Planning Commission Agenda Item

SUBJECT: FDP-08-2024 TROPICAL AND WALNUT. Applicant: DR HORTON.
Request: A Final Development Plan in a PUD (Planned Unit Development District) to Develop an 81-Lot, Single-Family Residential Subdivision. Location: Northwest Corner of Tropical Parkway and Walnut Road. (APN 123-30-201-007) Ward 1. (For Possible Action) (**Continued from October 9, 2024**)

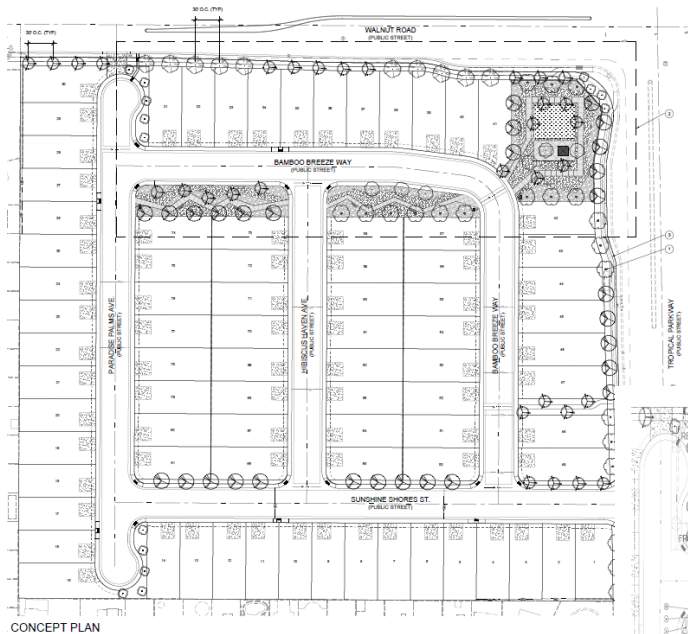
The submitted elevations indicate a two-story dwelling with a standard two (2) car garage. According to the proposed elevations, the dwellings would consist of primarily a stucco exterior, painted in three (3) different earth tone colors and a concrete tile pitched roof or tile shed style roof. The colored elevations provided generally comply with the design standards and are finished in earth tones indigenous to the Las Vegas Valley. However, the proposed elevations for the residential subdivision should incorporate additional architectural detailing on the front elevations. This can be addressed during the building permit process. The elevations submitted indicates three (3) distinct elevations will be offered per model for three (3) dwelling types consisting of 2,436 square feet up to 3,000 square feet. A subdivision development with 76-100 dwellings is required to provide three models units. Based on the size of the development three (3) models are required.

4. The elevations shall incorporate additional architectural detailing on the front of the dwelling.
5. The following amenities shall be provided within the open space areas: a tot-lot with EPDM surfacing; a barbeque area; a shaded ramada; benches; picnic areas; open turf areas; and dog station areas.
6. All driveways within the subdivision shall be made from brick or concrete pavers.
7. Setbacks for the lots are as follows:
 - Front setback – 10 feet (20 feet to garage)
 - Side yard setback – 5 feet
 - Corner side setback – 10 feet
 - Rear setback – 10 feet
